SUB: MODIFICATION SHEET No. RDSO/2023/EL/MS/0491 Rev. '00', dated 27.03.2023

MODIFICATION SHEET No. RDSO/2023/EL/MS/0491 Rev. '0', Dated 27.03.2023

Relocation of RS valve/Emergency Cock for ease of operation by Assistant Loco Pilot (ALP) in 3-Phase Electric Locomotives.

Fig.1 Existing Position of RS valve Handle

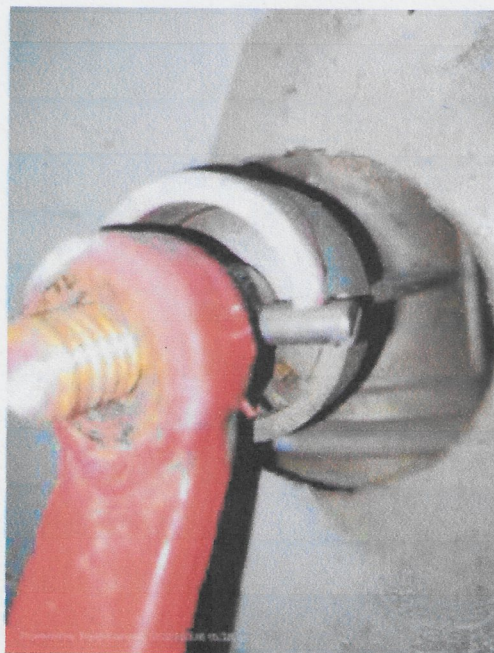
- 3.1 Presently, RS valve is provided on right hand side of ALP seat. RS valve handle is in vertical downward at 6 o'clock position in close condition and open at 9 o'clock position by rotating in clockwise direction.
- 3.2 In existing arrangement, bottom of RS Valve handle position is about 360 mm (approx.) above from cab floor level.

- 4.1 As per modified arrangement RS valve handle to be rotated in anti clockwise direction from 12 o'clock position(closed) to 9 o'clock position(open). The existing locking screw provided on spindle of cock to restrict operation between 6 o' clock & 9 o' clock to be removed and a lock plate as per drawing & photographs (enclosed) to be provided in such way that the operation should be restricted between 12 o' clock-closed and 9 o' clock-open.
- 4.2 With the implementation of the modification, the top position of the RS Valve handle will be about 735 mm (Approx) above from cab floor level.

Fig.2 Existing Locking Screw

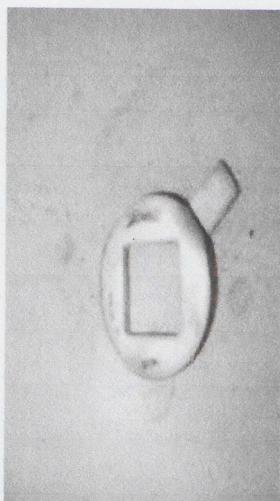
Locking Screw 02 nos. per locomotives
